Team Update 00

Team Update 00 details the changes of consequence between the 2020 and 2021 INFINITE RECHARGESM Game Manual.

Figure 4-2: POWER CELL setup inside RENDEZVOUS POINT

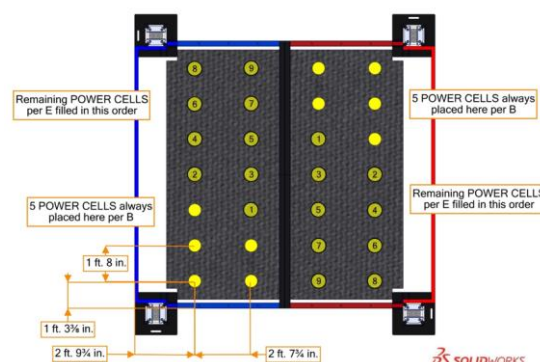
- **RENDEZVOUS POINT:** The Black BOUNDARIES that bisected an ALLIANCE's RENDEVOUS POINT have been removed. The Red and Blue BOUNDARIES nearest to the TRENCH RUNS have been removed and replaced with tape lines (note the tape lines are aligned to the far edge of the Truss Bases, resulting in the RENDEVOUS POINT becoming slightly larger). See 3.2 Zones and Markings for details.
- **RENDEVOUS POINT - POWER CELLS:** POWER CELLS that were staged on BOUNDARIES will now be staged on the Floor Protection inside the RENDEVOUS POINT. See Figure 0-1 and Figure 0-2 for details.

Figure 0-2: POWER CELL setup on ~~BOUNDARIES~~ inside RENDEZVOUS POINT

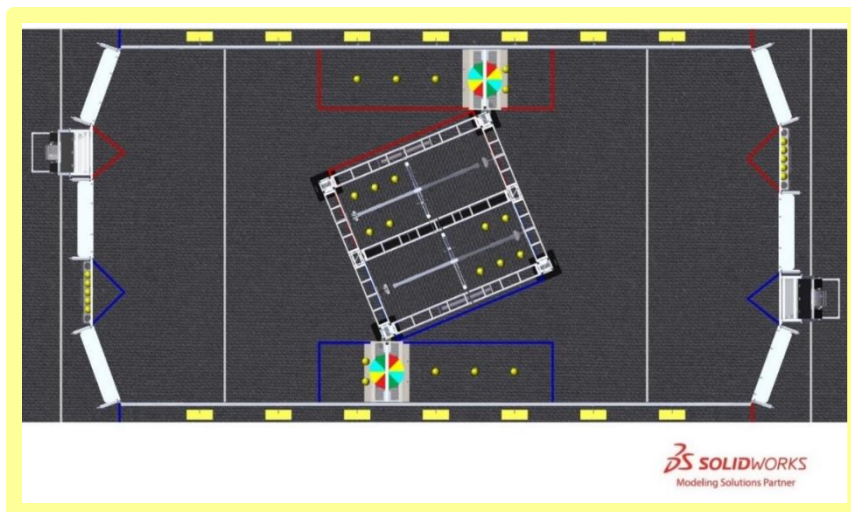
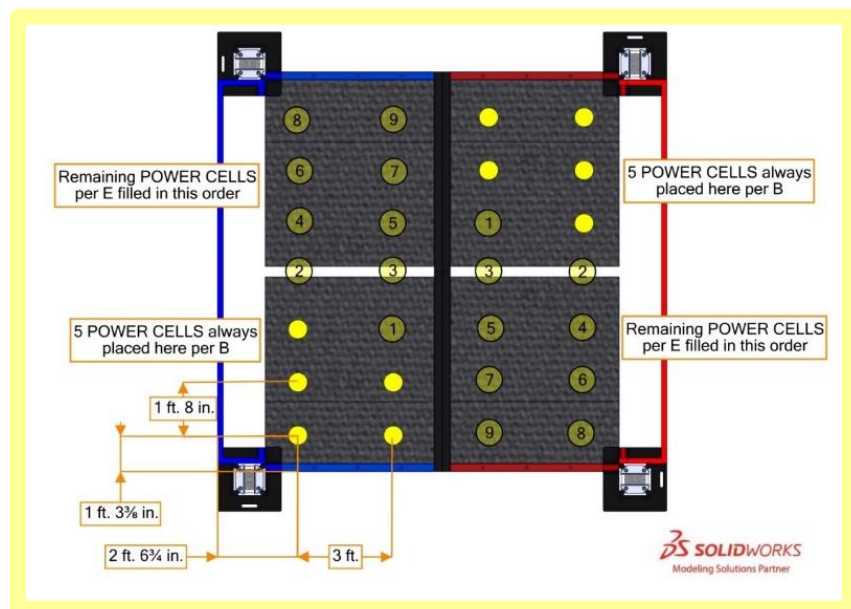
- D. each of the three (3) teams may preload up to three (3) POWER CELLS in their ROBOT, such that they are fully and solely supported by that ROBOT, and
- E. remaining POWER CELLS (zero (0) to nine (9) per ALLIANCE, depending on decisions made in D) ~~in the holes in the BOUNDARIES in~~ inside the corresponding ALLIANCE'S RENDEZVOUS POINT as shown in Figure 4-2.

Figure 0-3 G10 and G11 examples

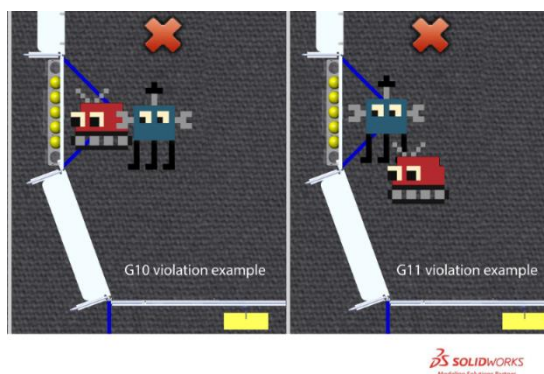
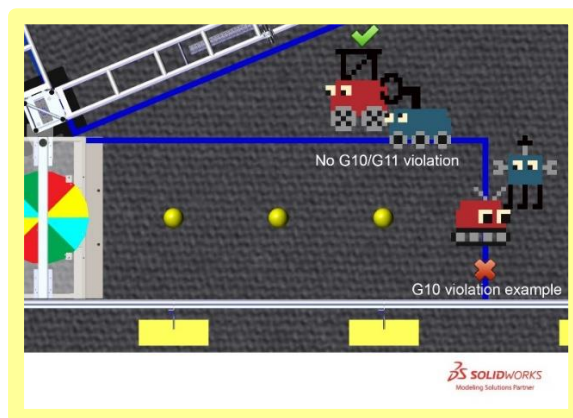
G11. Give opponents some space. An opponent ROBOT may not contact a ROBOT whose BUMPERS are intersecting its TARGET ZONE or LOADING ZONE, regardless of who initiates contact. ROBOTS in violation of G10 are exempt from this rule.

Figure 9-4 BUMPER color example

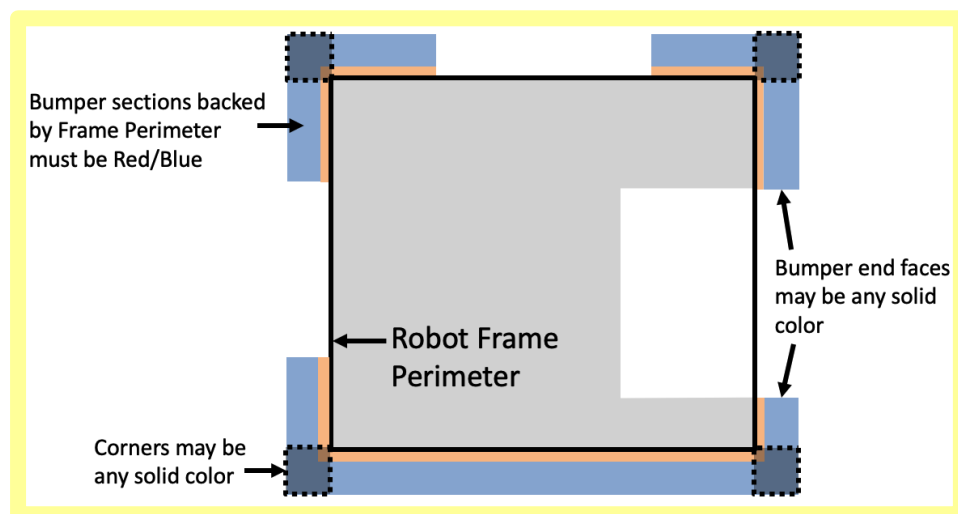
- **BUMPERS:** Bumpers are permitted to have non-alliance specific colors on their corners for the 2021 season. See R21 and R24D for details.

BUMPER corners and "ends", shown in Figure 9-4, must be solid in color, but do not need to be the same color as the rest of the BUMPER, as described in R21.

Figure 0-4 TIMEOUT and BACKUP Coupon Timeline

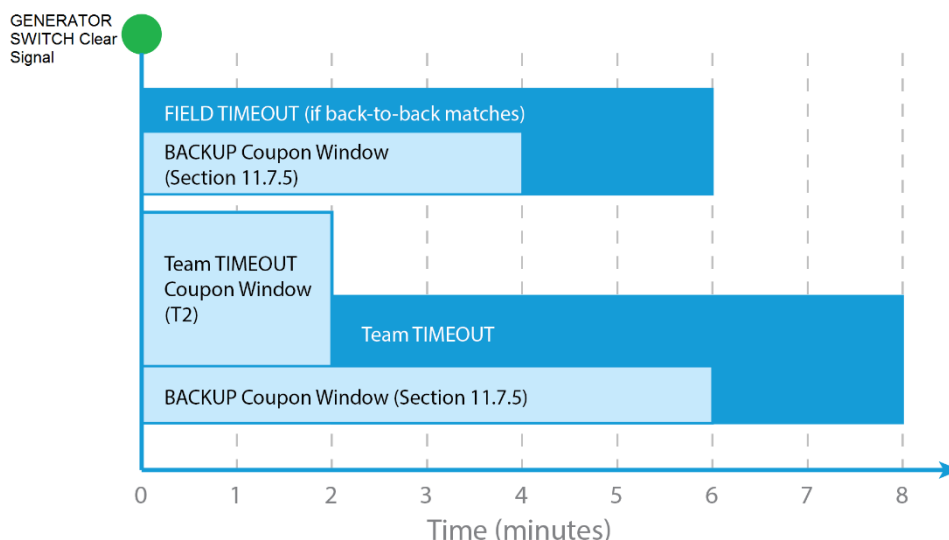
- T3.** If an ALLIANCE wishes to use their TIMEOUT, the ALLIANCE CAPTAIN must submit their TIMEOUT coupon to the Head REFEREE within two (2) minutes of the GENERATOR SWITCH Clear signal preceding their MATCH. If there is no preceding MATCH, the TIMEOUT coupon must be submitted no later than two (2) minutes before the scheduled MATCH time. The TIMEOUT will begin two (2) minutes after the GENERATOR SWITCH Clear signal (i.e. at the end of the Team TIMEOUT Coupon Window depicted in Figure 0-4)
